ISIS/TUFLOW MODEL UPDATE Review

Study: Thames Climate Change update

Job Name: River Kennet Climate Change Hydraulic model
Job No: 37454/4001
Note No: TN001 Rev A
Date: 04th January 2017
Prepared by: Shumol Bari
Subject: **Lower Kennet Flood Study (TH641) Hydraulic Model 25%, 35% and 70% Climate Change Model Runs**

Study: Kennet Climate Change update

Figure 6: TUFLOW Mass Balance plots

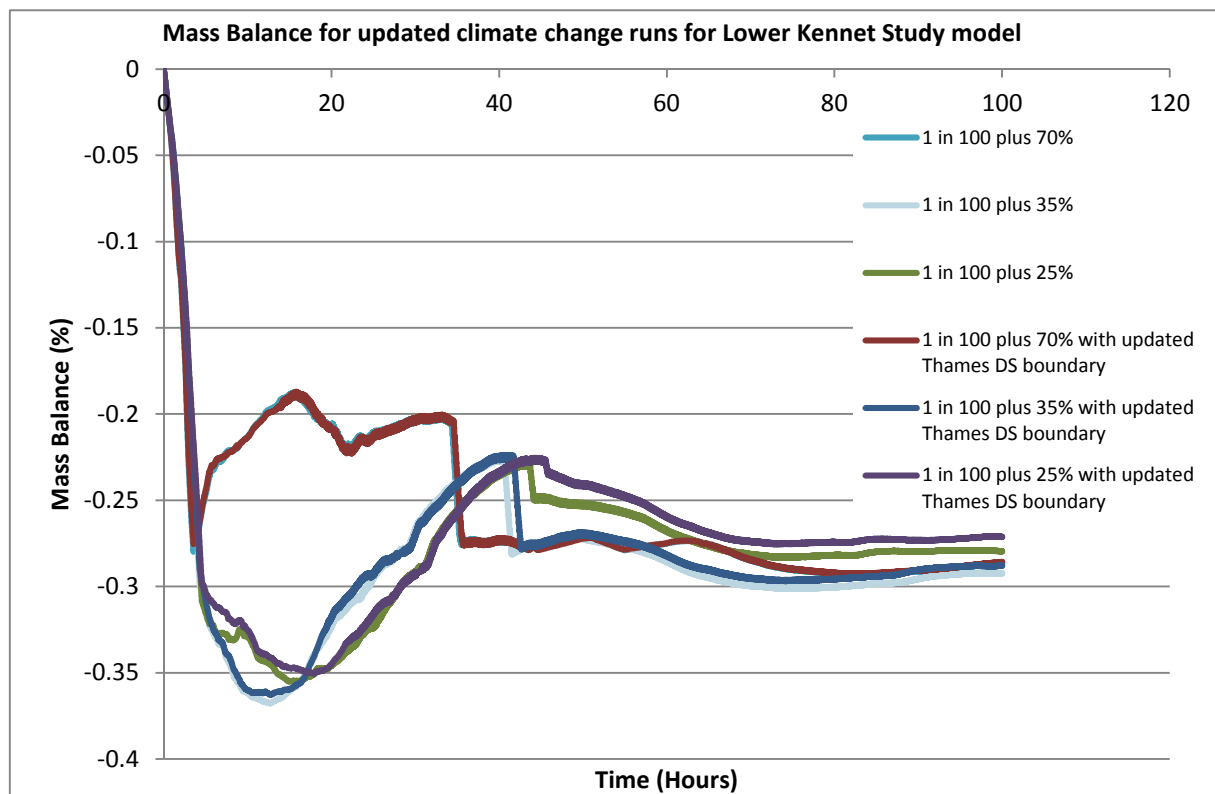
Are the 1D and 2D convergence plot showing particular struggle in convergence and stability?	The Mass balance error plots show good model performance.
Model Inflows	
Are the updated inflows appropriate?	The inflows originally increased by 20% were updated in order to have a total increase of 35% and 70%. <i>See Thames at reading climate change update model review.</i>
